Technical Service Bulletin

MODEL(S) AFFECTED: Speed Scrub 17", 20" and 24" Models with Propel

Speed Scrub 17/20/24 (SS3)

Replacement Control Board Module Rev. 03 (p/n 1052260).

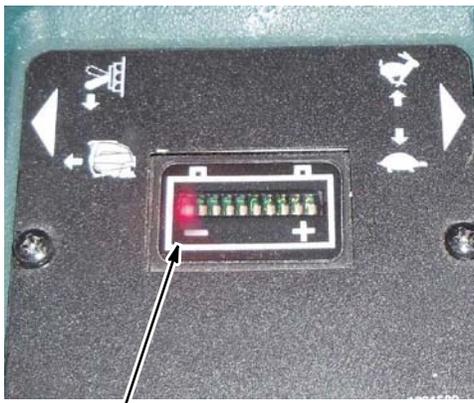
SUBJECT: False Battery Discharge Indicator reading. If BDI charge level rapidly drops upon machine start up, the control board module may have a program error.
Note: The actual run time is not affected by false BDI reading, the batteries will continue to discharge as normal.

False BDI reading when batteries are fully charged. The actual run time is not affected by the false reading, the batteries will continue to discharge as normal.

PURPOSE: To correct the BDI reading, replace the control board module with revision 03 (p/n 1052260). The revision level is located on module's label as shown below.

Replace control board module with Revision 03.

Note: The revision level 03 may be hand-written due to existing inventory was reprogrammed.
